Public comment on Oak Woodlands items on Fort Ord Committee agenda 23 March 2017  
(County of Monterey, Board of Supervisors)

Fred Watson, Ph.D.

## Options 4&5

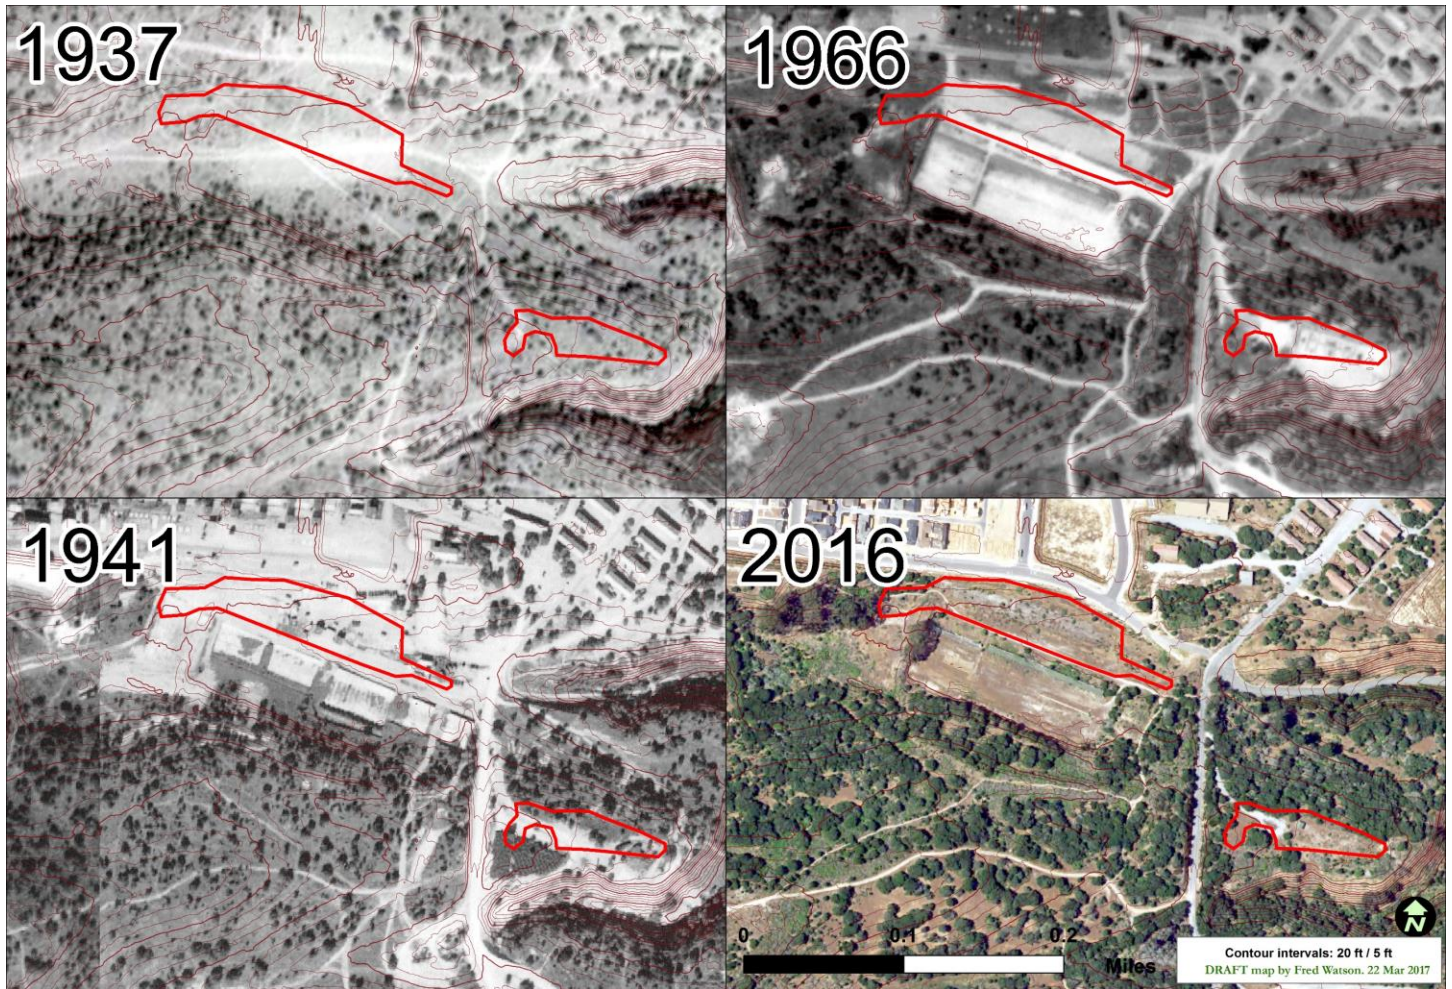
### a. Option #5: East Garrison #1

- i. Unsuitable for desired purpose
- ii. Sufficient restoration less likely to succeed than in other options

- iii. Less well-connected to other oak woodland than other sites
  - iv. Site was very unlikely to have supported dense oak woodland prior to Army use (see maps to follow). Statement in conclusion of consultant memo is not supported: “The East Garrison #1 site very likely supported dense coast live oak woodland prior to being graded and converted to a shooting range.”

- v. The reason for there being minimal historical oak cover at this site is that it lies predominantly in a topographic hollow or “swale” in which the soils are poorly drained and in which cold air accumulates on frost nights, limiting the growth of trees. Such swales in this part of Fort Ord are typically occupied by vernal pools and grasslands, not oak woodlands. A vernal pool formerly existed in essentially the same swale as the Option #5 site, about 0.2 miles to the west (clearly visible in 1941 imagery, and evident in 1937 imagery).

- b. Option #4: East Garrison #2
- i. I agree with consultant’s conclusion. Site is too small.
- c. Option #3: Trail
- i. I agree with consultant’s conclusion: “site has not historically supported oak woodland habitat.” (see maps below)

## Option 2

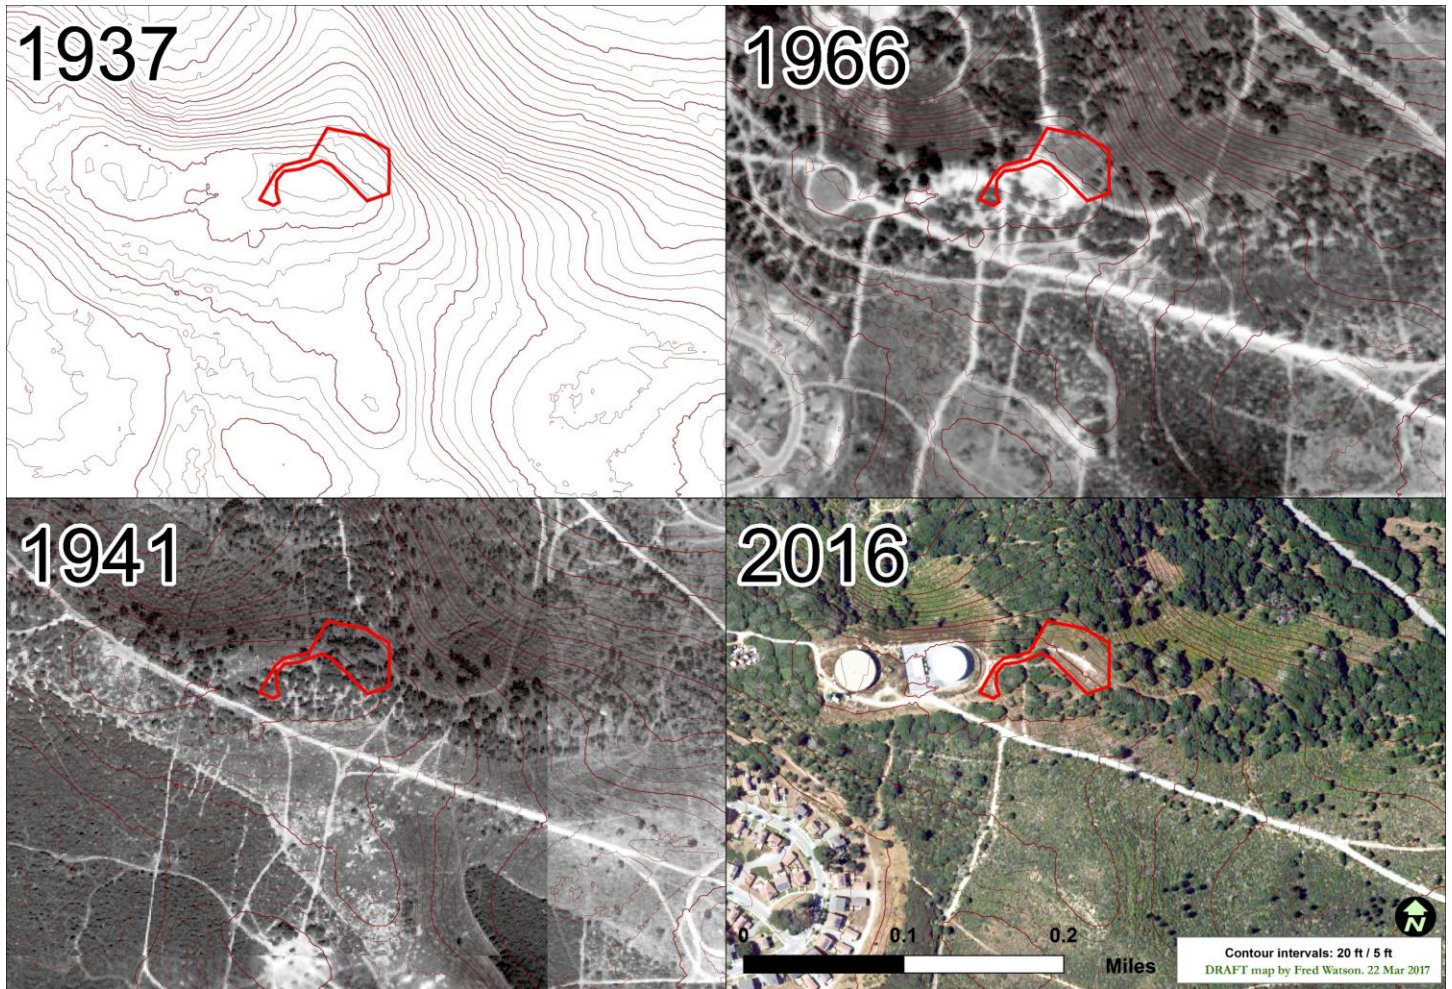
- d. Option #2: Tanks
- i. I agree with consultant’s conclusion. Site is too small.
- e. Option #1: Eucalyptus Road
- i. This is the best option of the five presented by the consultant

## Option 1

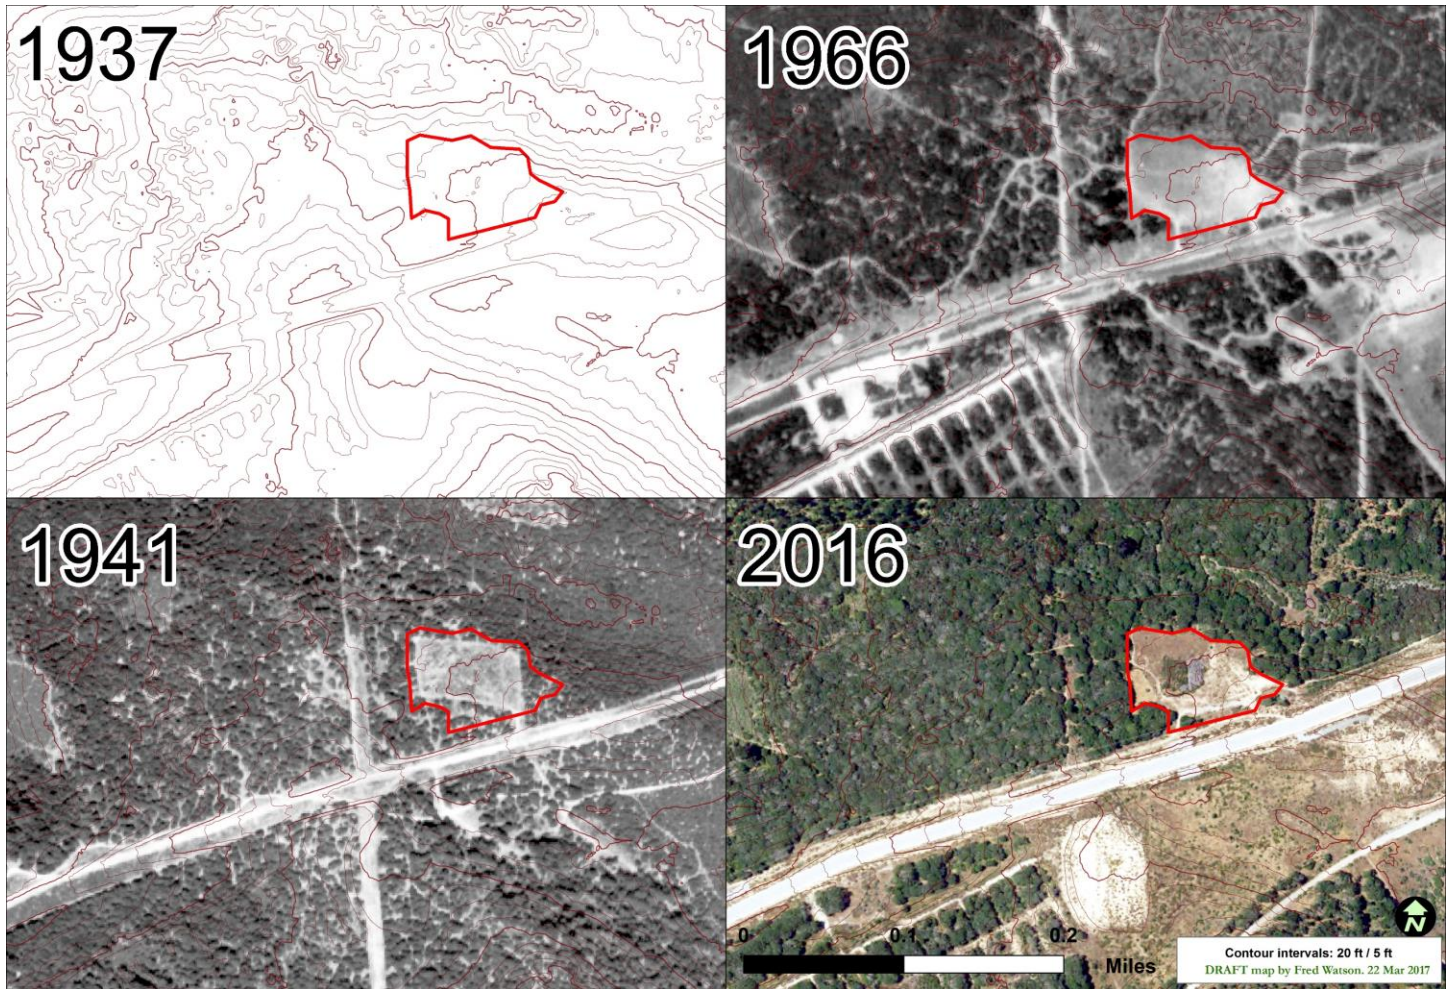
- ii. Surrounded on three sides by dense oak woodland”, and formerly supported part of that same woodland (see maps below). A scenic “Elfin Forest Trail” runs through the area. Area is also close to oak-wooded high-visibility ridgeline on south side of Eucalyptus Road, which of significant value as an natural open-space amenity within the overall Fort Ord redevelopment context.

## Tree cover / oak cover – two approaches to mapping

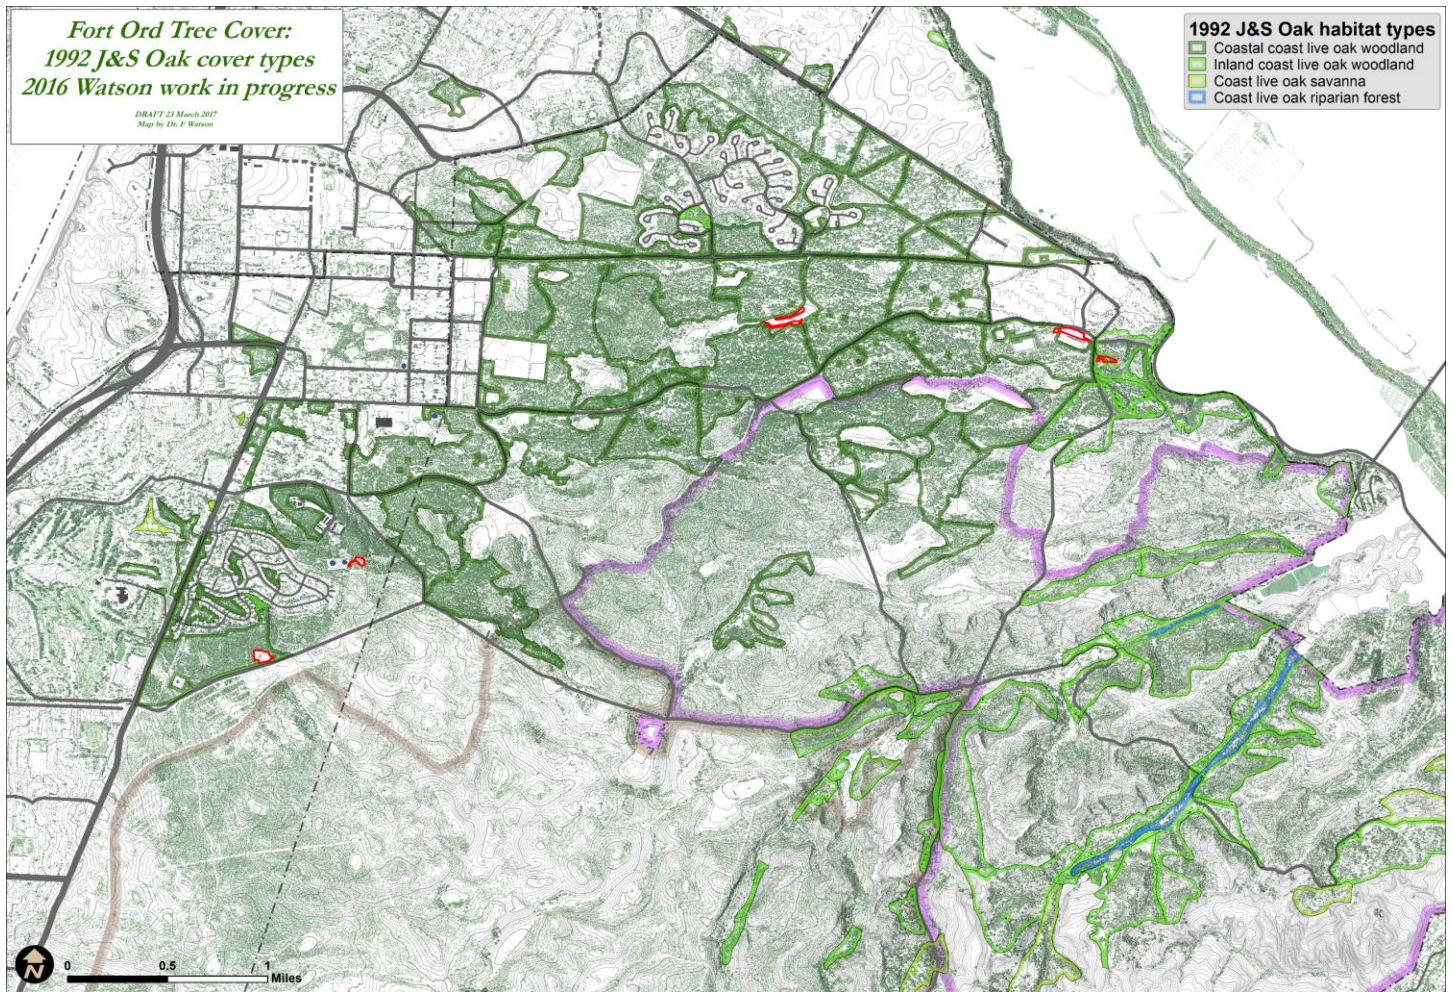
- i. The memo makes several references to “mapped oak woodland”. The source of this mapping should be stated, and the map should be made available for public review. A sufficiently accurate public map of oak woodlands on Fort Ord has perhaps never been produced. The 1992 Jones & Stokes map is perhaps the best

public map, and it is approximate in general, inaccurate in some places, and outdated in others.

- ii. See “Fort Ord Tree Cover” map below for an illustration of the how quantification of oak cover depending on the mapping approach. In this map, the underlying green texture essentially indicates probability of tree cover (usually oaks, except in developed areas); and the overlay shows the 1992 Jones & Stokes mapping used in the Fort Ord Reuse Plan and several subsequent documents.

# Trail map

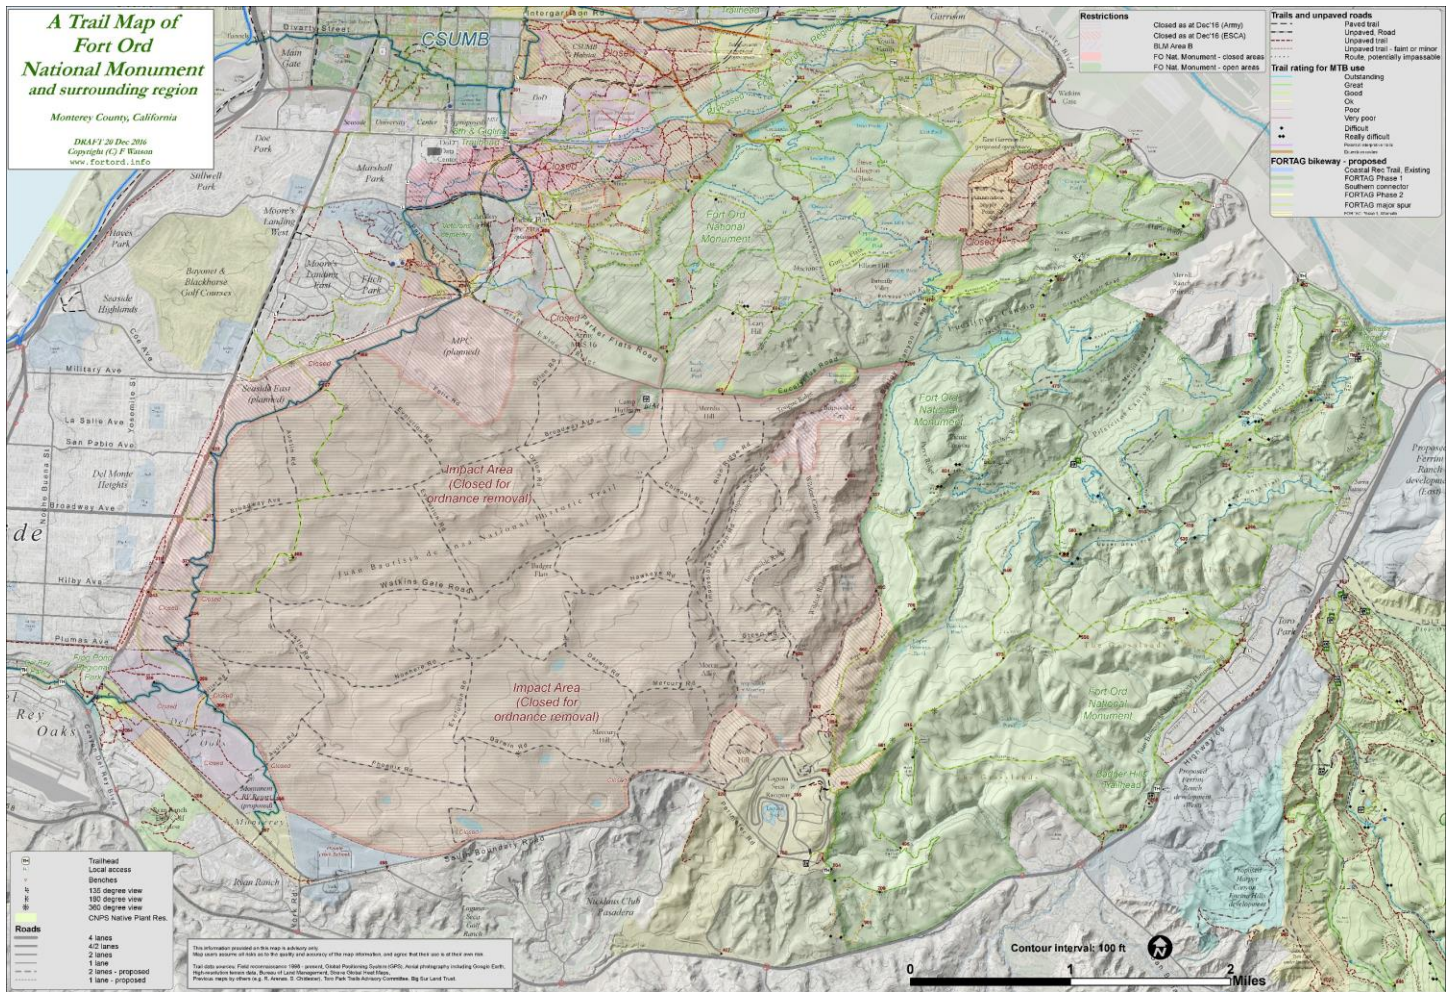
- i. Recreational trails run through most of the proposed sites. Some are heavily used. Trails should be shown on oak restoration planning maps.
- ii. Oak restoration should not in general preclude or obvert trails, and this should be specifically recognized in restoration plans (unless there are compelling reasons to avoid trails in specific restoration areas). At the site-specific level, trails and oak conservation are generally compatible land uses. Trail users are strong advocates for oak woodland conservation, and enhancement of the trail experience is a key benefit of oak woodland conservation. At a more-regional level trail density can be modulated to enhance wildlife habitat by limiting trail density in certain areas identified as having regional ecological conservation priority.

- iii. A detailed and current map of all trails in the region is shown below. This map can be obtained from [www.fortord.info](http://www.fortord.info).
